TO: Mercedes-Benz Dealer Principals, General Managers, Sales Managers, Service Managers, Parts Managers	FROM: Anthony Washington, Senior Manager, Regulations and Certifications
Re: Launch Recall Campaign Notification Model: Sprinter (907) Model Year: 2023 Inspect Main Wiring Harness Routing	DATE: April, 2024

IMPORTANT RECALL CAMPAIGN INFORMATION

Campaign No. :	Campaign Desc. :	Inspect Main Wiring Harness Routing
2024030019	VS3BEFHAU	
<p>This is to notify you of a Recall Campaign to inspect the main wiring harness routing on approximately 828 MY 2023 Mercedes-Benz Sprinter Vans. The recall campaign will be visible on the www.safercar.gov website and may generate questions from customers. All affected VINs will be flagged as "OPEN" in VMI and cannot be sold.</p>		
Background		
Issue	<p>Mercedes-Benz AG ("MBAG"), the manufacturer of Mercedes-Benz Sprinter vehicles, has determined that on certain Sprinter vehicles, the routing of the main wiring harness might not meet specifications. In this case, the wiring harness might contact the drive shaft, and chafe Over time, this could result in a short circuit of various wires in the harness. Depending on the affected wire, a risk of fire,

D54.18-A060-78

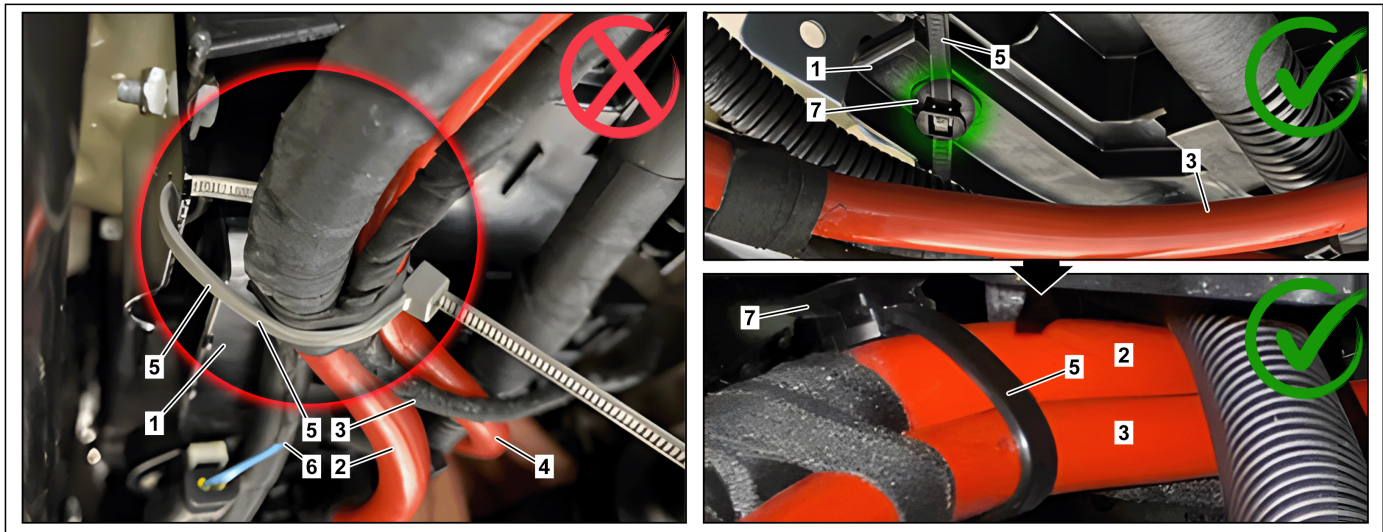
3	Check routing of wiring harness for starter-alternator.	<p>i</p> <p>For correct routing, see picture 2: Attach wiring harness bundle with cable tie (5) and retaining clip (7) to holder (1). To do so, clip retaining clip (7) into hole (1.1) (picture 1).</p> <p>For incorrect routing, see picture 1 and 2:</p> <ul style="list-style-type: none"> - Cable tie attached to sheet metal (picture 2, left) - Cable tie (5) attached to holder (1) on wrong side (picture 1, center) - Wiring harness fastened so that electric lines run too close to propeller shaft (picture 1, center) <p>If alternator line (2) or electric steering line (4) is damaged,</p> <p style="text-align: center;">↓</p> <p>replace damaged alternator line (2) and/or electric steering line (4). Repair is not permissible.</p> <p>If electric lines (3, 6) are damaged,</p> <p style="text-align: center;">↓</p> <p>repair respective damaged electric line (3, 6).</p> <p>If mount is not correct,</p> <p style="text-align: center;">↓</p> <p>continue with operation step 4.</p>

Correct mount of wiring harness			
4	Cut cable tie (5).	<p>i</p> <p>Replace cable tie (5).</p>	
5	Position alternator line (2), electric steering line (4) and electric lines (3, 6) correctly and fasten.	<p>ⓘ</p> <p>Do not kink any electric lines and ensure that they are routed without any chafing. This prevents any damage.</p> <p>i</p> <p>For correct routing, see picture 2: Attach wiring harness bundle with new cable tie (5) and retaining clip (7) to holder (1). To do so, clip retaining clip (7) into hole (1.1) (picture 1).</p>	
	Install		
6	Lower vehicle.

If alternator line (2) is damaged: Order main wiring harness with item number **A 907 540 84 65** and branch off required new alternator line (2) from wiring harness.
